SERVICE BULLETIN

AIR - INTRODUCTION OF TWO ZONE 2 AIR DEFLECTOR BRACKETS - CATEGORY CODE 3 -
MOD.ENG-75-0005

V2500-ENG-75-0005

View showing air deflector bracket - Before and after alteration
Fig.1

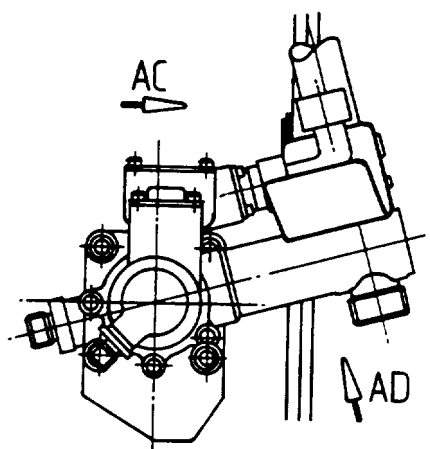
- (2) The changes introduced by this Service Bulletin are as follows:
 - (a) A new air deflector bracket for the 7/10 stage cabin air valve which is bolted to the diffuser case at the fuel burner position on the port side twenty seven degrees from top dead centre. There is already another bracket installed at this position, this mean one of the three securing bolts has to pass through both brackets. In order for the air deflector bracket to fit properly the mounting points are at different heights.

VIEW  AB
BEFORE ALTERATION

VIEW  AB
AFTER ALTERATION

View showing air deflector bracket - After alteration
Fig.2

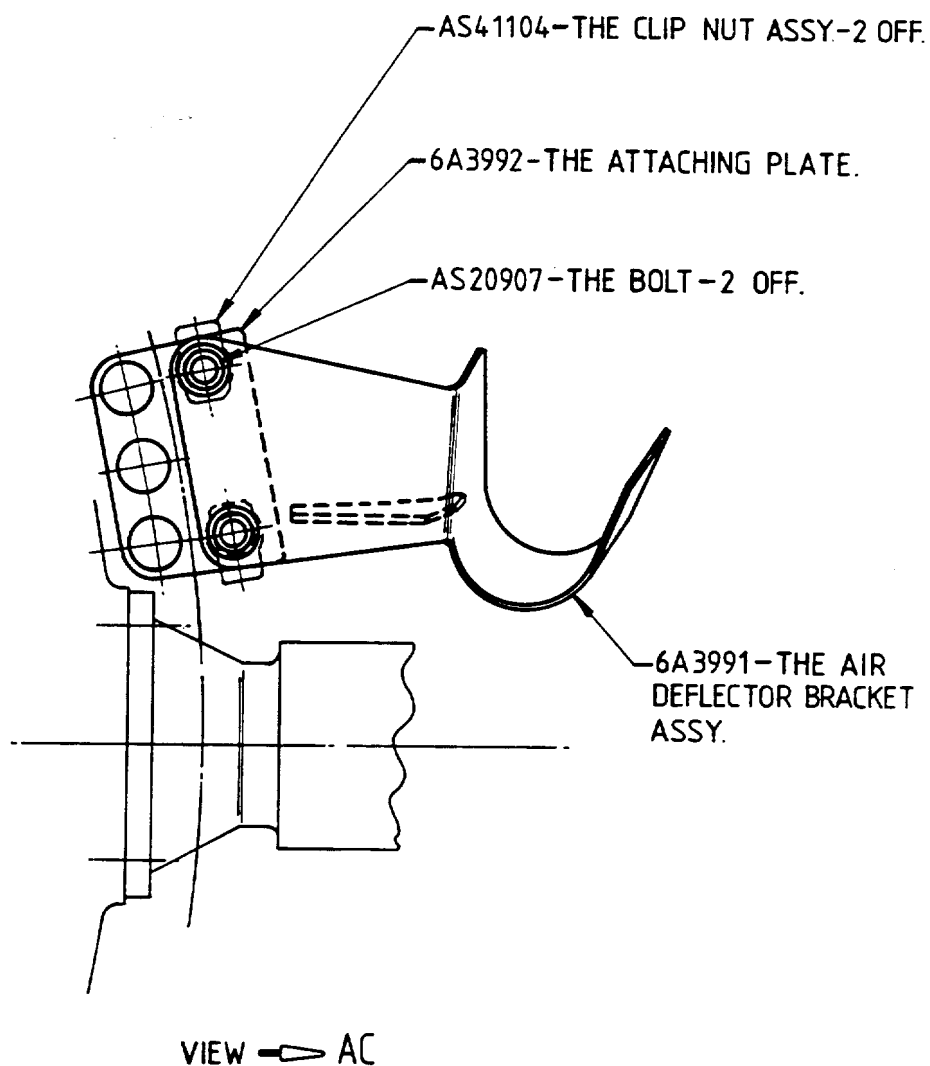
- (b) A new air deflector bracket for the stage 10 position is attached to a new attaching plate which is installed on the rear flange of the HP compressor rear outer case. The attaching plate is attached by flange bolts, two new bolts and clip nuts. It is necessary to move the T3 harness clipping bracket round one pitch to prevent it fouling with the air deflector bracket. On assembly of the air deflector a maximum clearance is to be kept between the electrical connector and the castellated nut of the adjacent cooling air pipe.

View showing air deflector bracket - After alteration
Fig.3

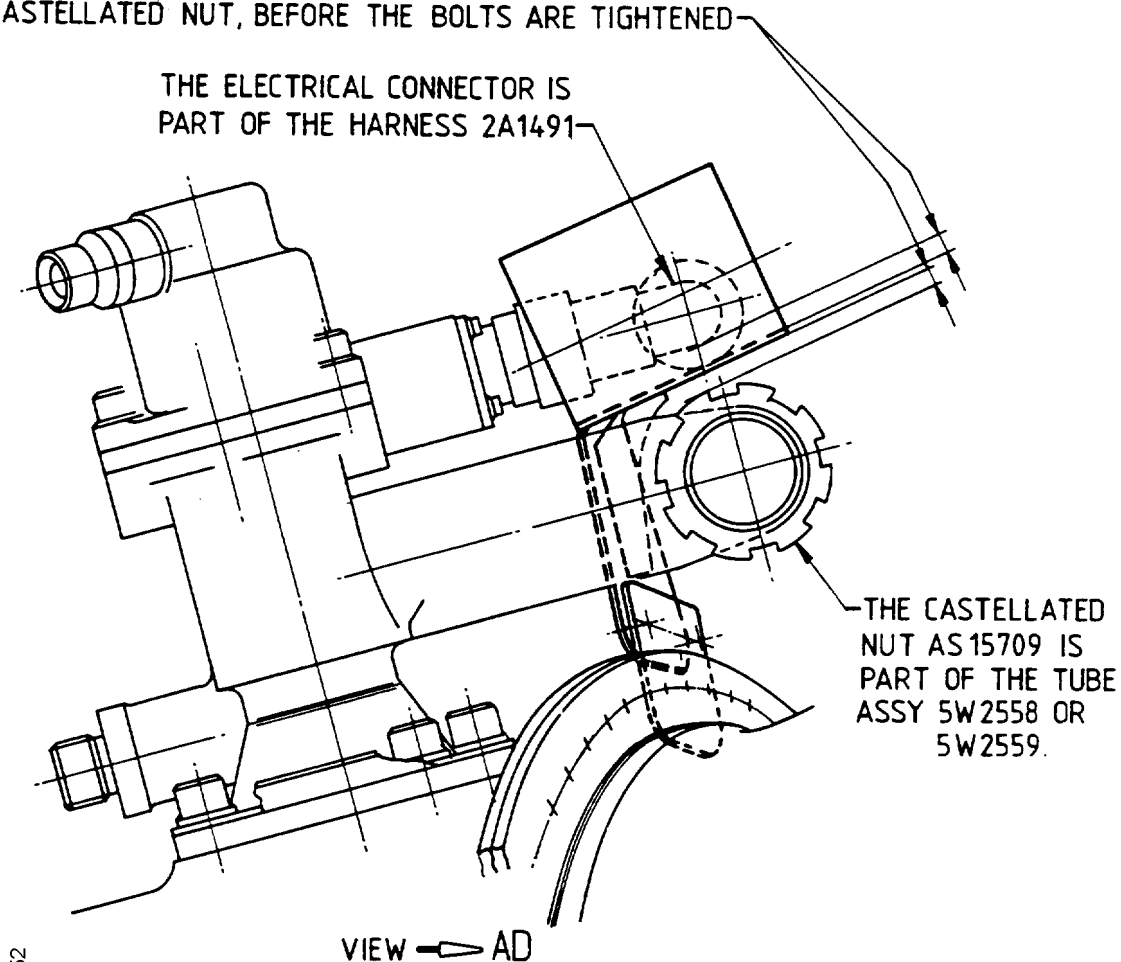
ADJUST THE POSITION OF THE DEFLECTOR BRACKET
TO BE APPROXIMATELY IN THE MIDDLE OF THE SPACE
BETWEEN THE ELECTRICAL CONNECTOR AND THE
CASTELLATED NUT, BEFORE THE BOLTS ARE TIGHTENED

THE ELECTRICAL CONNECTOR IS
PART OF THE HARNESS 2A1491

THE CASTELLATED
NUT AS 15709 IS
PART OF THE TUBE
ASSY 5W2558 OR
5W2559.
